AIA® Document G701® – 2017

Change Order

PROJECT: *(Name and address)*
 FBC African American Memorial
 BD 24-059
 630 Charlie Roberts Lane
 Kendleton, TX 77451

CHANGE ORDER INFORMATION:
 Change Order Number: 001
 Date: 12/03/2025

Sheet Title:
**PHASE 2 SCOPE &
 ALTERNATES**

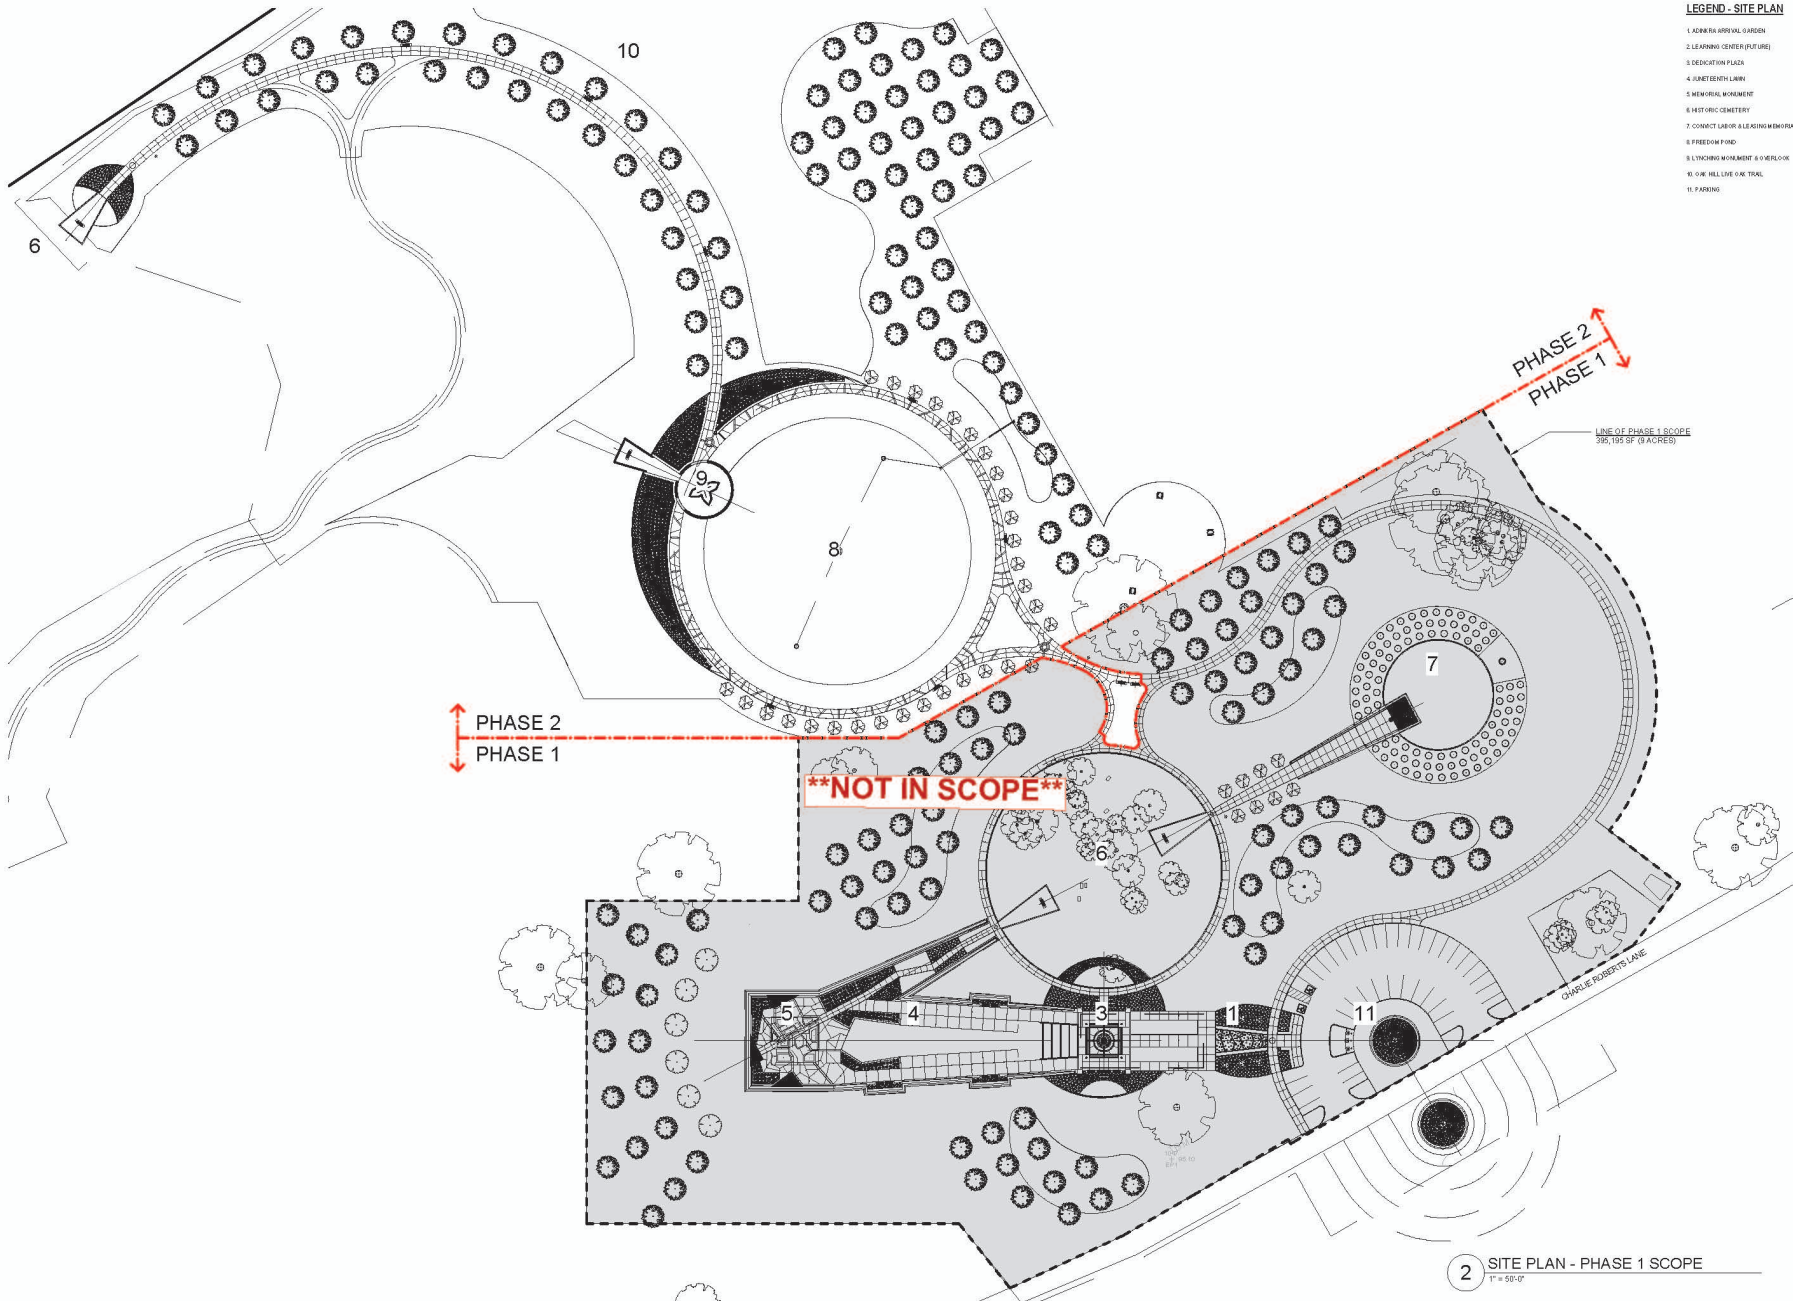
Phase 1 VE Items:

- CLL Axis gabion wall
- Parking Lot Entrance Gabion wall and Signage
- Dedication Plaza Pedestals
- Full light scope
- Cementry overlook with bench
- Wood toppers for benches
- Monument sealant

Phase 2 Full Scope based on pending approved plans.

- See page 3 for scope of work.
